Access Compliance Report

Public Rights-of-Way

Intersection ID: 44892	Main Street: SAMS_LN	Cross Street: UNIVERSITY_CITY_BV	Location: NW
ADA ID: 99BBA3455AC7	Ramp Type: Perp	Initial Pass/Fail: Fail	Overall Compliance: No
		Severity Score: 25

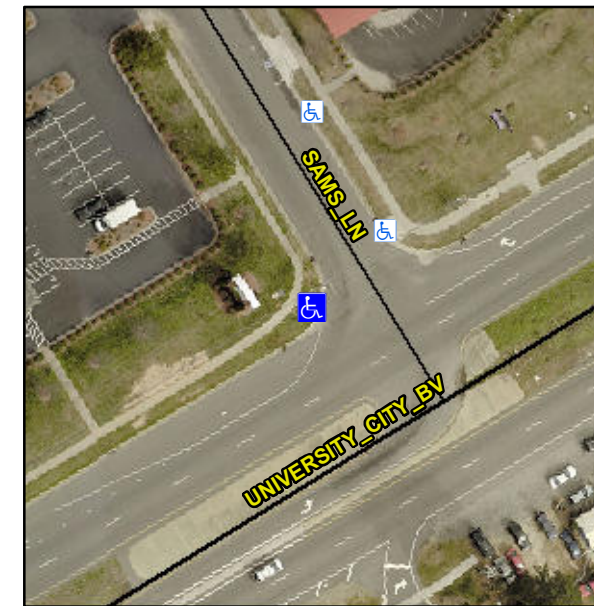
Not Found, R304.2.2

Compliance	Description	Data	Compliance	Description	Data
N/A	Ramp Length (in)	25.0	No	Ramp Slope (%)	20.0
Yes	Ramp Width (in)	57.0	Yes	Ramp XSlope (%)	0.0
N/A	Flare Type LT	N/A	N/A	Flare Type RT	N/A
N/A	Flare Slope LT (%)	N/A	N/A	Flare Slope RT (%)	N/A
N/A	Flare Traversable LT?	N/A	N/A	Flare Traversable RT?	N/A
N/A	Landing Length (in)	N/A	N/A	DWS Provided?	N/A
N/A	Landing Width (in)	N/A	N/A	DWS Contrast?	N/A
N/A	Landing Slope (%)	N/A	N/A	DWS Length (in)	N/A
N/A	Landing X Slope (%)	N/A	N/A	DWS Full Width?	N/A
N/A	Landing Curb? (Y/N)	N/A	N/A	DWS Offset (in)	N/A
N/A	Shared Landing?	N/A			
N/A	Gutter Ponding?	N/A	N/A	Gutter Slope (%)	N/A
N/A	Gutter Lip Ht (in)	N/A	N/A	Gutter X Slope (%)	N/A
N/A	Painted X Walk1?	No	N/A	Painted X Walk2?	N/A
	X Walk 1 Direction	To NE		X Walk 2 Direction	N/A
N/A	X Walk 1 Width (in)	N/A	N/A	X Walk 2 Width (in)	N/A
	X Walk 1 Slope (%)	3.1		X Walk 2 Slope (%)	N/A
	X Walk 1 X Slope (%)	3.4		X Walk 2 X Slope (%)	N/A

Remove & Replace Entire Ramp.
